AMENDMENTS TO THE DRAWINGS:

Submitted herewith is an amended FIG. 1.

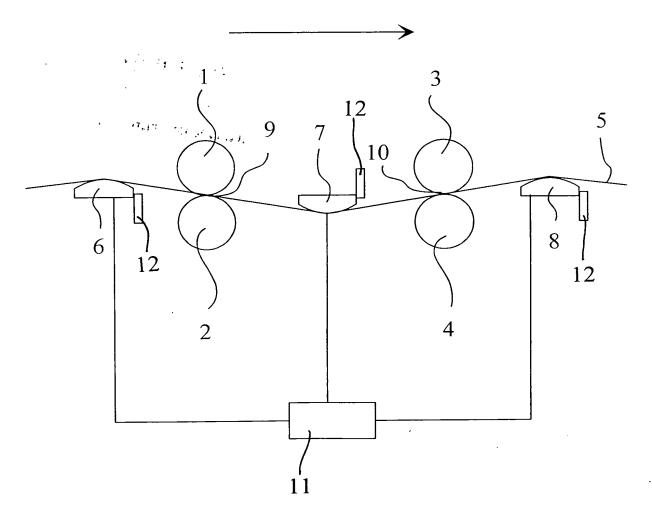
In response to the objection to the drawing under 37 C.F.R. §1.83(a), FIG. 1 has been amended to add the "air cutting device", now labeled 12, and a device to implement the "decision making algorithm", now labeled 11. As discussed below, the specification has been appropriately amended to refer to these reference numerals.
